**RESOLUTION NO. 20-222**

**RESOLUTION TO APPROVE REVISIONS TO THE EL PASO COUNTY  
ENGINEERING CRITERIA MANUAL AND ADOPTION FOR IMPLEMENTATION**

**TO:** Board of County Commissioners  
**FROM:** Jennifer Irvine P.E. MPA, County Engineer/ECM Administrator  
**DATE:** June 16, 2020  
**RE:** ECM-20-001 Engineering Criteria Manual (ECM) Revisions

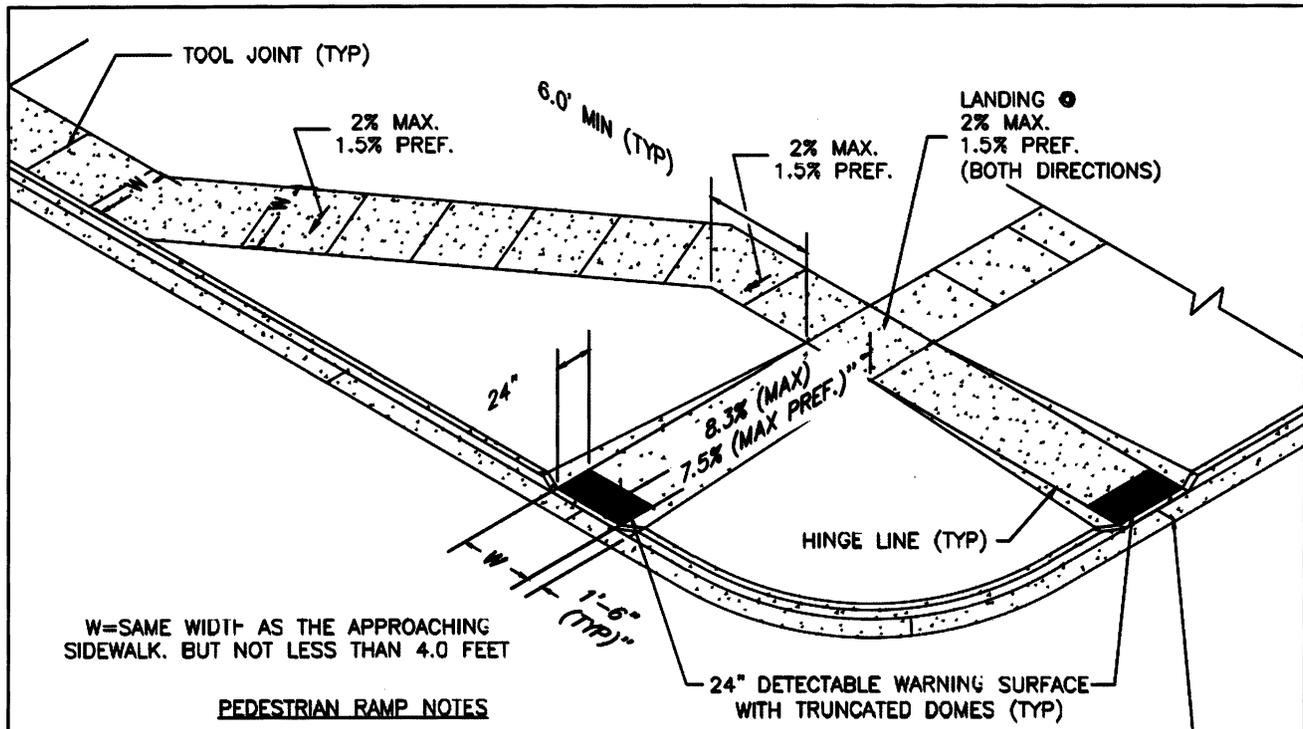
2.5.2.B.2	2-72	Revise paragraph: "Access crossings shall be designed in accordance with Standard Drawings SD_2-24 and SD_2-25 in Appendix F. Sidewalk across accesses should be accessible per the requirements of Chapter 6."	Recommended	Update SD_2-24 and SD_2-25 to clarify accessibility requirements.

SD_2-25		Modify to provide 4' minimum sidewalk width across driveway. Modify cross slope to show 2% max. (1.5% preferred). Add note to comply with ECM Chapter 6.	Recommended	Provide room for construction tolerance.
	Curb Ramps		Add language in ECM Chapter for other ramp designs permitted by PROWAG, and reference/utilize CDOT standard details if they are not found in EPC App F.	Recommended	
	SD_2-40		Change name to Pedestrian Curb Ramp Detail. Modify to provide 4' min. sidewalk width at the flared portion of sidewalk. Modify cross slope to show 8.3% max. (7.5% preferred). Change name to Detectable Warning Surfaces and refer to SD_2-42.	Recommended	Utilize current standard drawings, direct designers in ECM to propose other site specific designs if standard designs are not feasible.

9. SIDEWALKS ACROSS DRIVEWAYS SHALL BE ACCESSIBLE AND COMPLIANT WITH REQUIREMENTS OF ECM CHAPTER 6.

6/23/20	Pedestrian Curb Ramp		
DATE APPROVED:	Ramp		
Jennifer E. Irvine	Standard Drawing		P:\J-Std and other 2016\JegoShuttan.jpg
DEPARTMENT OF PUBLIC WORKS	REVISION DATE:	FILE NAME:	
	6/23/20	SD_2-41

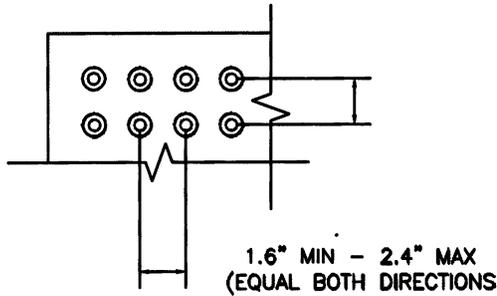
Revisions to other Documents/Sections Associated with new ECM Chapter 6 Accessibility					
Document	Section	Page	Recommended Revision	Required or Recommended	Potential Impacts
	SD_2-41		Change name to Pedestrian Curb Ramp Detail. Modify cross slope to show 2% max. (1.5% preferred) for sidewalk and landing. Modify running slope to show 8.3% max. (7.5% max preferred). Revise Note 4 to refer to Pushbutton Location per ECM. Change name to "Detectable Warning Surface" in multiple locations. Revise Note 6 regarding DWS to state the DWS should be prefabricated cast iron type. Revise Note 10 to state that drainage structures, traffic signal...are prohibited within ramp areas or landings. Add Note 11 to clarify 5% max. counter slope. In General Notes, add (Pedestrian Circulation Path) and (Pedestrian Access Route) for clarity. Change all instances to "Pedestrian Curb Ramp."	Required	Various revisions for consistency with Chapter 6. The County no longer uses the DWS mentioned in the standard and desires only cast iron type DWS.

3. PEDESTRIAN CURB RAMP CONSTRUCTION SHALL BE A MINIMUM 4,500 PSI CONCRETE, MINIMUM 4" THICK, NON-COLORED, NON-SCORED, COARSE BROOM FINISH.
4. PEDESTRIAN CURB RAMP LOCATION AND LENGTH MAY REQUIRE MODIFICATION TO MAINTAIN THE 8.3% MAXIMUM RUNNING RAMP SLOPE DUE TO STREET INTERSECTION GRADES AND/OR ALIGNMENTS. SEE ECM SECTION 6.3.6 FOR PEDESTRIAN PUSHBUTTON LOCATION REQUIREMENTS.

11. THE COUNTER SLOPE OF THE GUTTER OR ROAD AT THE FOOT OF A RAMP SHALL NOT EXCEED 5%.

6/23/20 DATE APPROVED:	Detectable Warning Surface Details	
Jennifer E. Irvine DEPARTMENT OF PUBLIC WORKS	Standard Drawing	P:\1-2008 and 11-10- Details\Logo2008outlet.jpg
REVISION DATE: 6/23/20	FILE NAME: SD_2-42

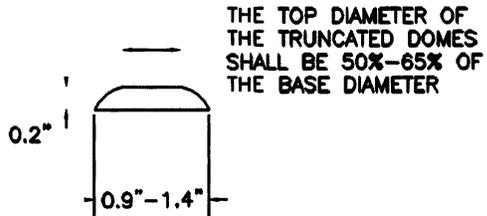
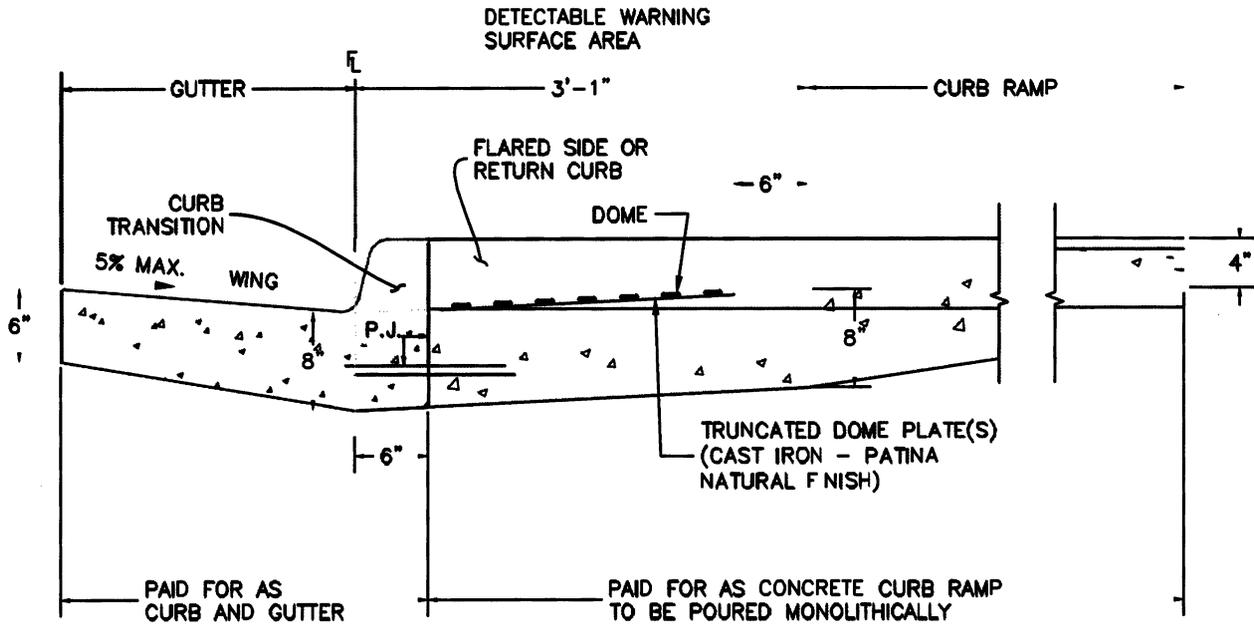
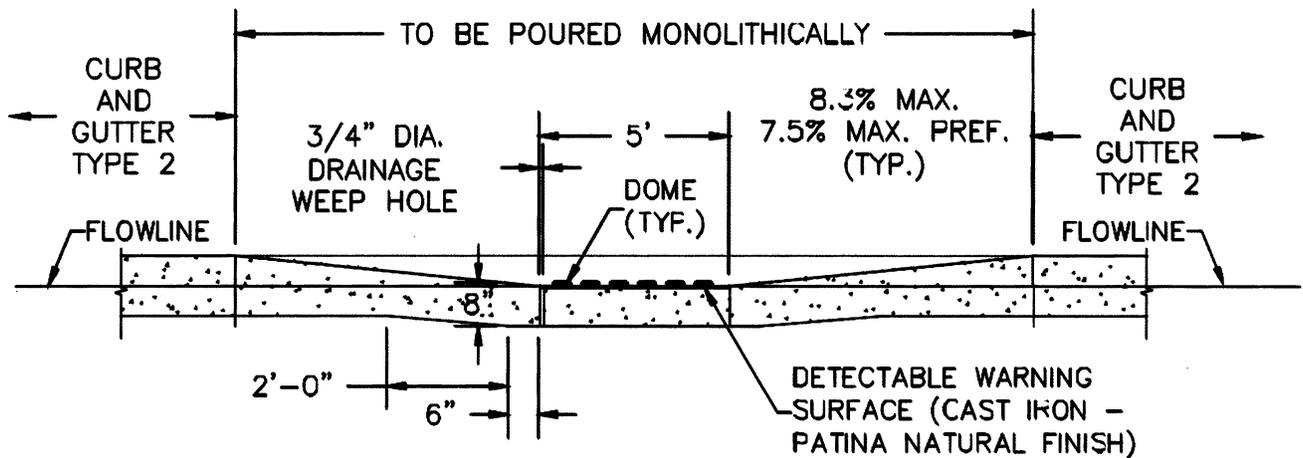
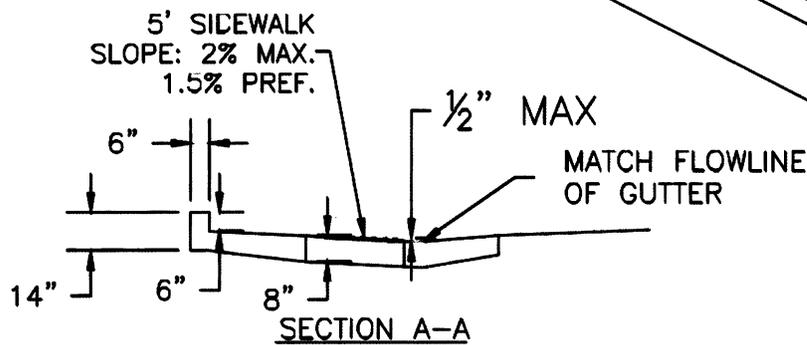
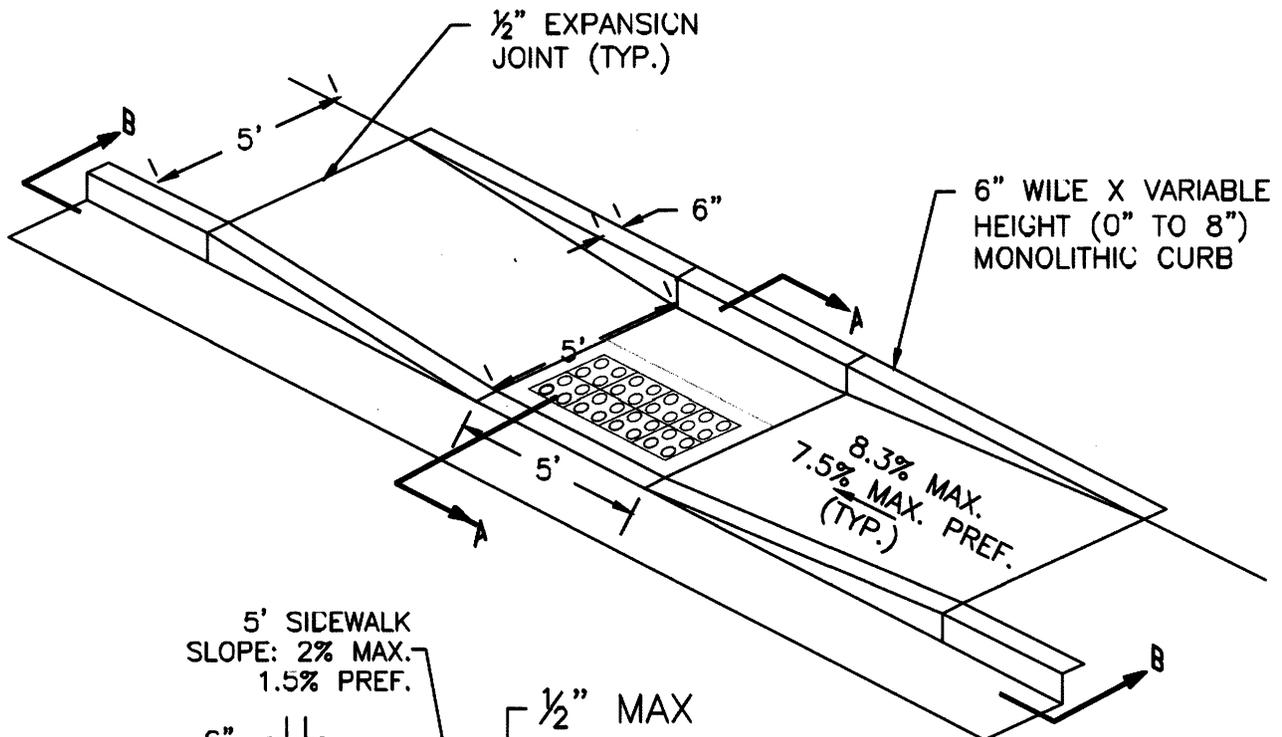
SD_2-42		Modify the DWS standard to be compliant with PROWAG and specify the material to be used as cast iron.	Recommended	Consistency with Chapter 6
	SD_2-50		Change name to Parallel Pedestrian Curb Ramp Detail. Modify cross slope to show 2% max. (1.5% preferred) for turning space. Modify running slopes to show 8.3% max. (7.5% max preferred). Modify DWS to show cast iron type.	Recommended	
<b>Design Checklists</b>					
			Add design checklists for pedestrian access routes and curb ramps.	Recommended	Provides designers and contractors with a way to verify their designs meet PROWAG requirements. Checklists will not be included in ECM or required as part of official project file. They will be available as a recommended tool during project development.
<b>EPC Land Dev. Code</b>	5.2.36.D.1.i.	5-49	Add bullet: "Method for accommodating pedestrians" to requirements for Traffic Control Plan	Recommended	Consistency with Chapter 6
